In the Matter of)
NORTHERN STATES POWER COMPANY) DOCKET NO. 50-263
)
Monticello Nuclear Generating) Violation of Provisional
Plant, Unit 1) Operating License No. DPR-22
) (Modification and Installation
) of Defective Spent Fuel Storage
) Racks)

REQUEST AND MOTION FOR ORDER PROHIBITING
THE INSTALLATION OF DEFECTIVE SPENT FUEL
STORAGE RACKS IN VIOLATION OF PROVISIONAL
OPERATING LICENSE, REQUEST TO INSTITUTE A
PROCEEDING, AND PETITION FOR LEAVE TO INTERVENE

SUBJECT: SWELLING IN G.E. HIGH-DENSITY SPENT FUEL STORAGE RACKS

Figure 1

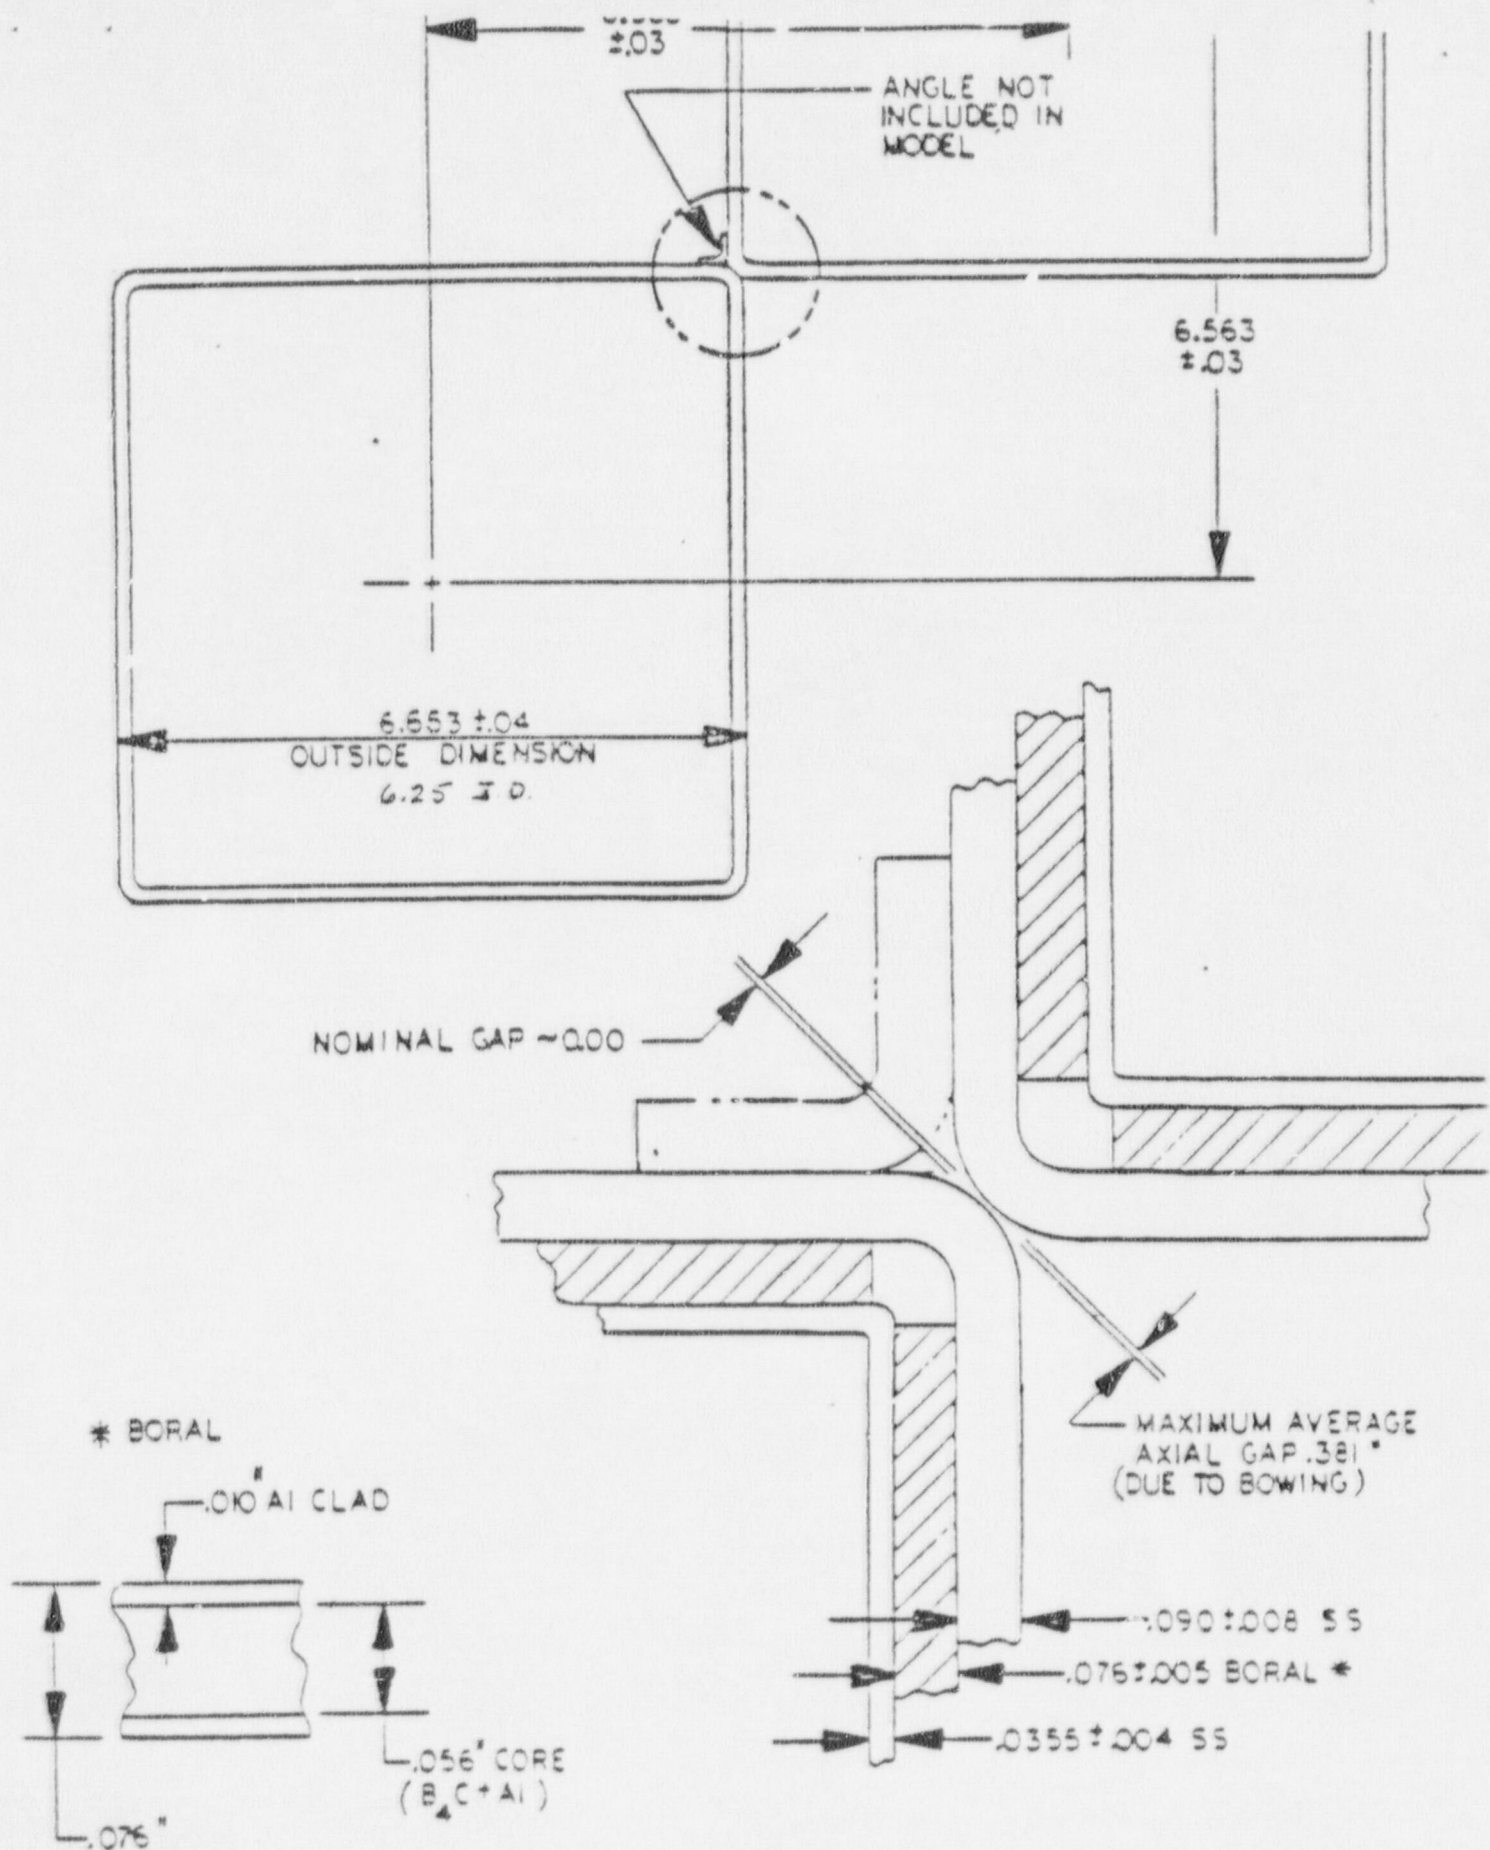
After the tubes were fabricated and inspected at Brooks and Perkins, the tubes were fabricated into racks (modules) at Memphis, Tennessee by CBIN/GE. As shown in Figure 2, an angle is welded onto the sheet metal tubes to join them together. When the initial racks were being fabricated by CBIN, there were instances of burn-through during welding of the angles.

The sandwich construction of the tubes was intended to be leak-tight. It appears that the leaks in the tubes at Monticello (evidenced by the bubbling and swelling) was most likely the result of (1) failure to seal the tubes during fabrication at Brooks and Perkins, (2) the welding performed on the tubes during fabrication of the racks at Memphis and/or (3) on stresses induced on the angle welds during transport and handling of the racks.

1. To approve GE's proposal to drill a hole in the top of the tubes in the four racks currently in the Monticello SFP and the four racks at Browns Ferry Unit No. 3 to prevent swelling in these racks.
